S BROOKS ST

SHEET 1 OF 2

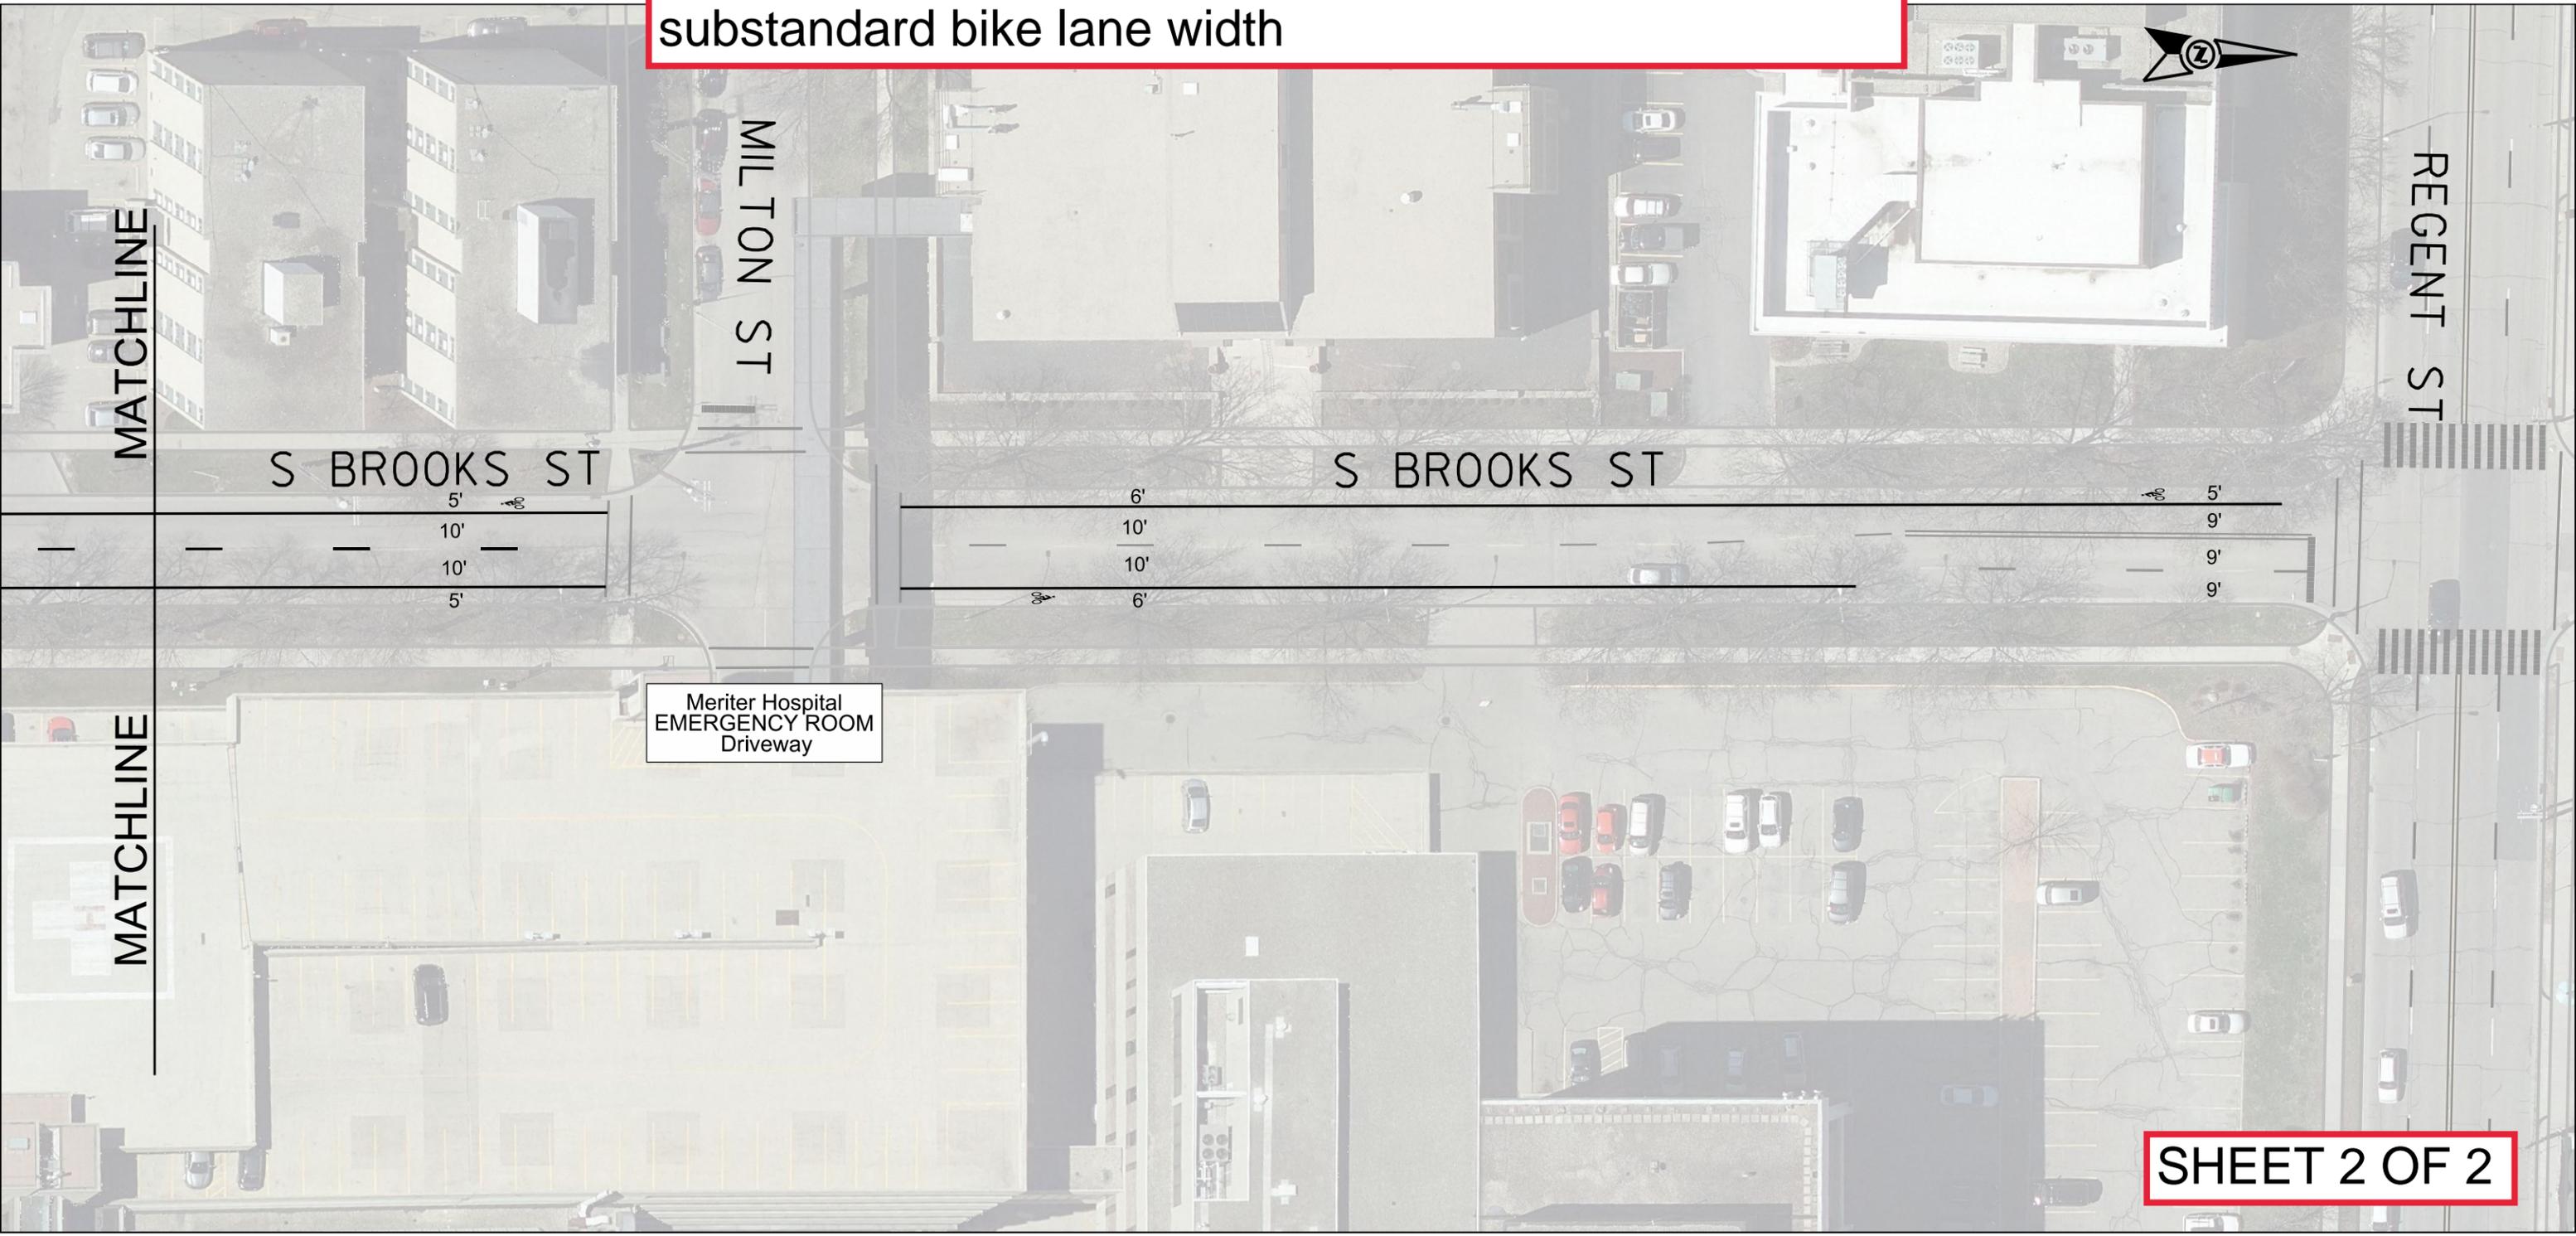
Not recommended by City Traffic Engineering due to substandard bike lane width
